SUNDRY NOTICES AND REPORTS ON WELLS
Do not use this form for proposals to drill or to re-enter an abandoned well. Use form 3160-3 (APD) for such proposals.

8. Well Name and No.
NAVAJO ALLOTTED GAS COM A 1

9. API Well No.
30-045-13252-00-S1

PLUG AND ABANDONMENT PROCEDURE

Proposed WBD

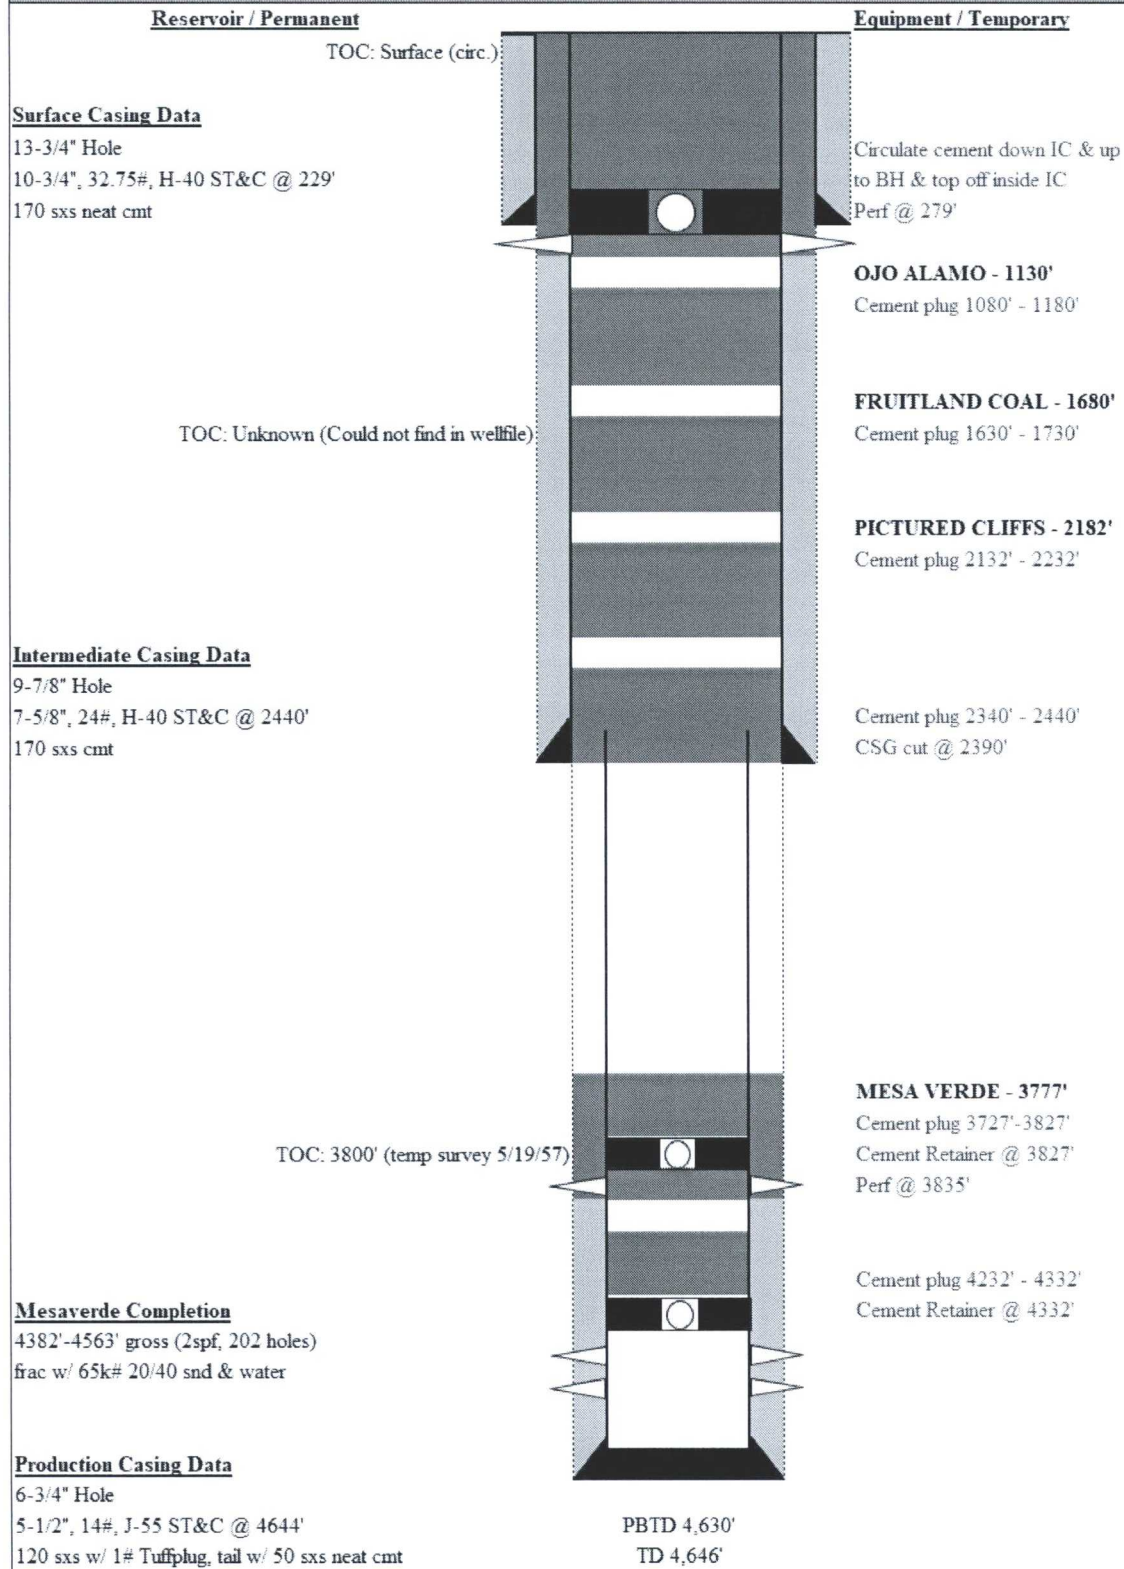
Based on the logs and Eric's comments below, we would like to propose the following changes to the procedure (attached). The estimated TOC is ~1950' from the CBL, and flow suggested from the noise log was present from 1250' to surface with restrictions/channeling at approximately 800', 700', 550', and 100'. We do not believe flow is present between the production and intermediate casings. A cement retainer was set at 4332' yesterday.

1. Set MV perforation plug as planned in original procedure (attached).
2. **Plug #2:** Spot balanced plug to isolate the Mesa Verde top. Mix and pump 18 sx class G cement (1.15 cf/sk, 15.8 ppg) from 3827' – 3727'.
3. **Plug #3:** Spot balanced plug to isolate the Pictured Cliffs top. Mix and pump 18 sx class G cement (1.15 cf/sk, 15.8 ppg) from 2232' – 2132'.
4. Cut 5-1/2" production casing at ~1900'. Pull production casing from 1900' to surface.
5. **Plug #4:** Spot balanced plug to isolate the production casing stub. Mix and pump 18 sx class G cement (1.15 cf/sk, 15.8 ppg) from 1950' – 1850'.
6. Run CBL, temperature, and noise logs inside 7-5/8" intermediate casing from 1850' to surface. Continue with originally outlined procedure.

- a) Add a cement plug (3128 – 3028) ft. to cover the Chacra top. BLM picks top of Chacra at 3078 ft.
- b) Set Plug #4 (2161 – 2061) ft. to cover the Pictured Cliffs top. BLM picks top of Pictured Cliffs at 2111 ft.
- c) Set Plug #5 (1850 – 1750) ft. to cover the Fruitland top. BLM picks top of Fruitland at 1800 ft.
- d) Set Plug #6 (1380 – 1100) ft. to cover the Kirtland top and the entire Ojo Alamo interval. BLM picks top of Kirtland at 1330 ft. BLM picks top of Ojo Alamo at 1150 ft.

Thanks for the update. There are a few changes that have been made to your plug depths based on our tops, and I have added a Chacra plug as well. I have attached the COA and the geo report as you requested. Please let me know if you have any questions or concerns regarding the changes to your procedure.
